1000 Boylston Street Project BOSTON, MA

SUPPLEMENTAL INFORMATION DOCUMENT

RE: Supplemental Information Document
1000 Boylston Street Project, Boston MA

Chapter 2: Response to Comments

Figure 1.8

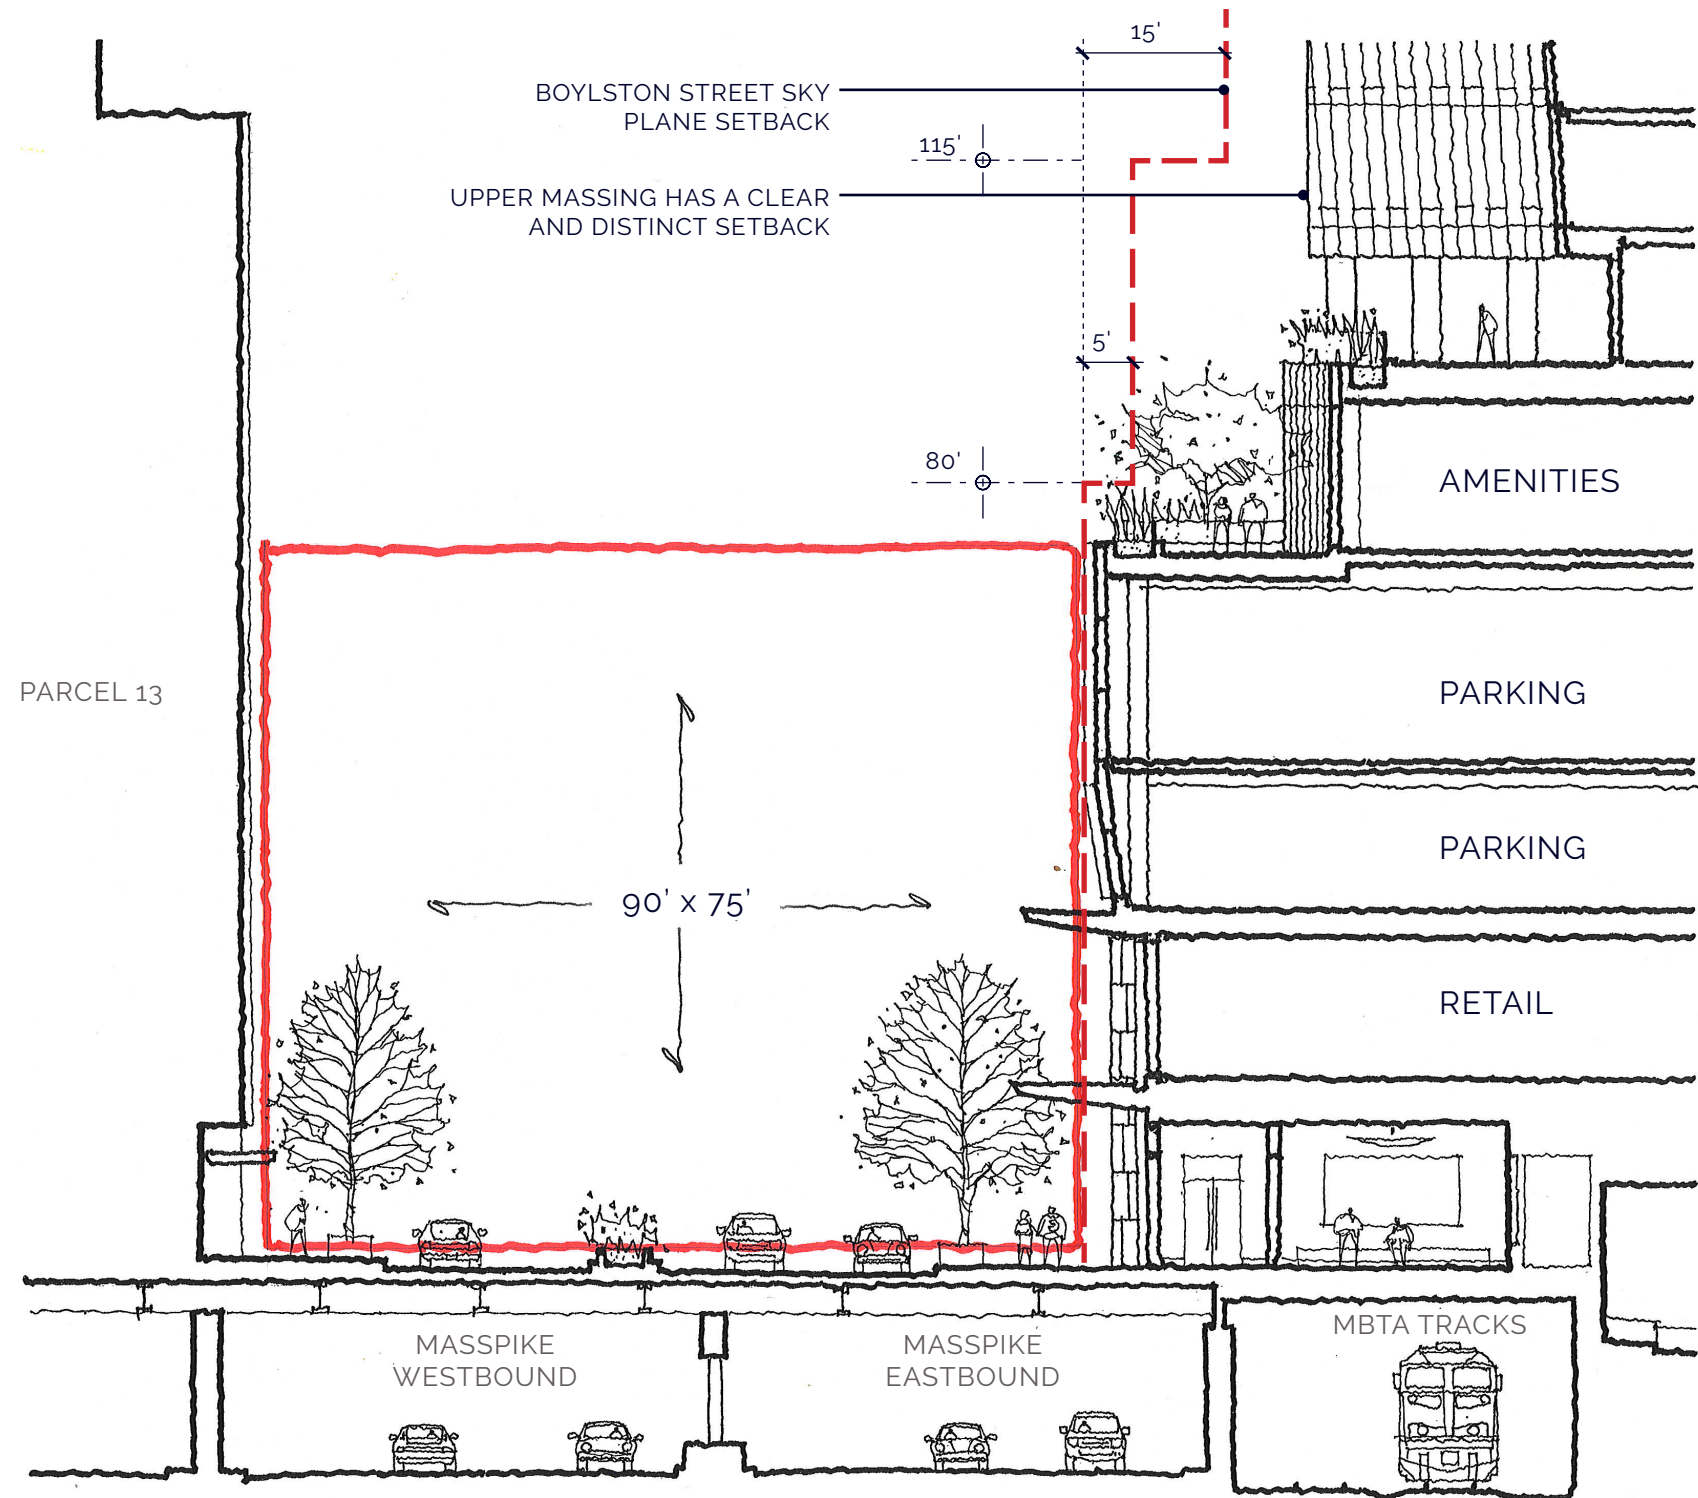
Many members question not just whether 18' is sufficient but also whether the 18' width will remain free of obstructions that would hamper the anticipated pedestrian volumes. There will be many demands for the same space—trees, planters, benches, "respite" seats, sidewalk cafes, street furniture and signage. Most members strongly dislike the Decaux advertising structures that cause considerable pedestrian congestion elsewhere in the Back Bay, and recommend that no such street furniture on this site be allowed by the City. We urge BPDA to evaluate carefully the necessary width to serve pedestrians, and encourage the use of novel approaches, such as the Hudson Yards tree pits.

As shown on Figure 1.8, the proposed Boylston Street public realm improvements include an expanded sidewalk from 11'-6"-wide to 18'-6"-wide. As shown on Figures 1.9 and 1.10, the design of the Boylston Street sidewalk takes a multifaceted approach to accommodate the urban needs for this important corridor and implements a strategy to enhance the pedestrian experience based on the City of Boston 'Complete Streets' guidelines. As recommended by the Complete Streets guidelines, the length of the sidewalk is categorized into the following three distinct zones:

Figure 1.18

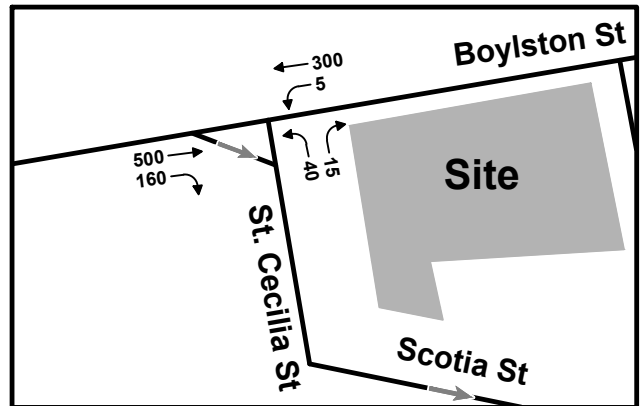
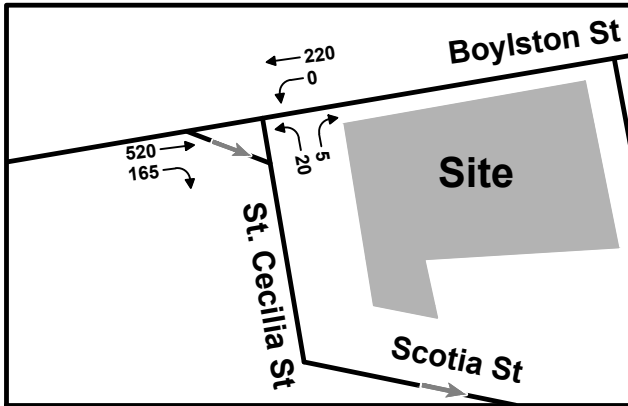
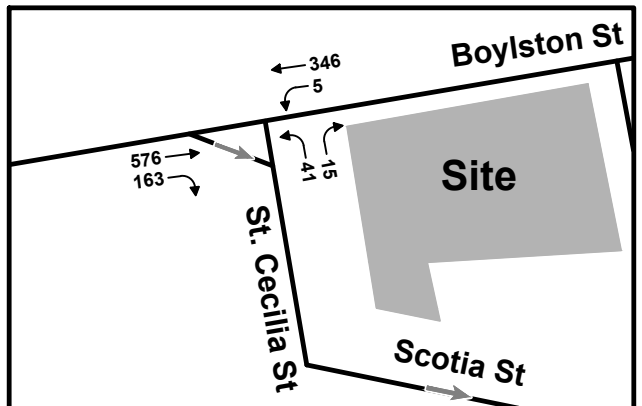
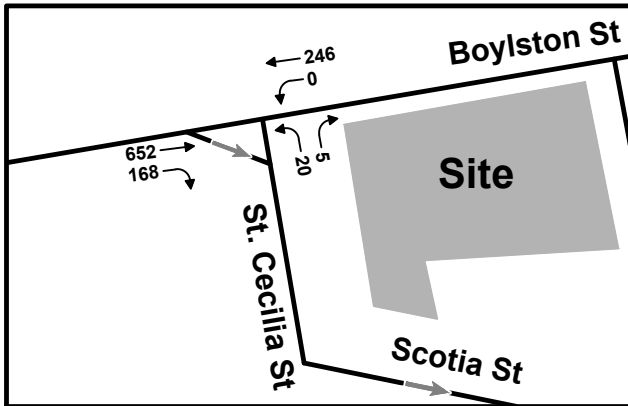
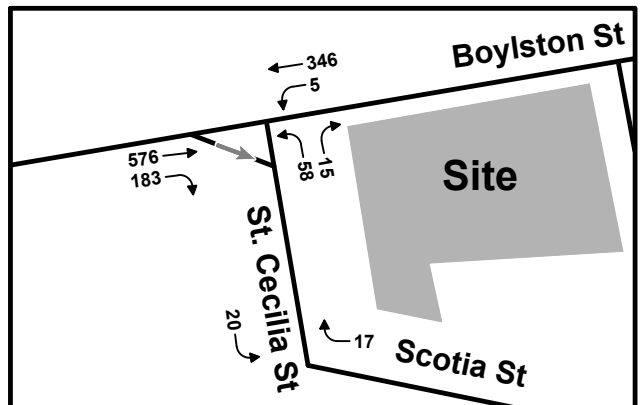
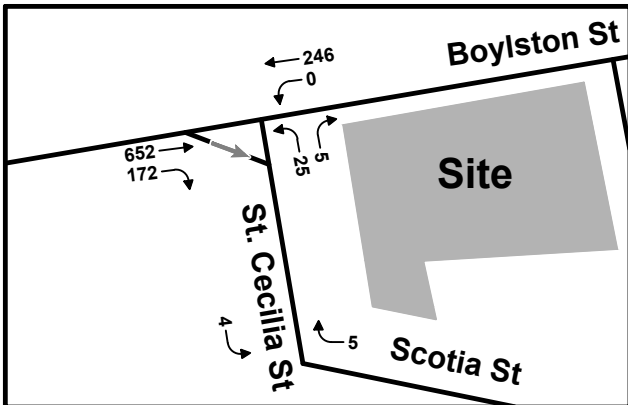
The proponent proposes making some of Scotia Street two-way. BTD would like the proponent to examine the impact of this change on the intersection of St. Cecilia and Boylston, especially of those wishing to make a left onto Boylston and how that will affect this and neighboring intersections.

Morning and evening peak hour traffic counts were conducted at this location on Thursday, November 30, 2017. Figure 1.18 presents the vehicle volumes for the morning and evening peak hours. The volumes were used to model the intersection using Synchro 9.0 software to calculate vehicle delays for the St. Cecilia Street northbound left turn and right turn movements under both existing and future No-Build and Build conditions.
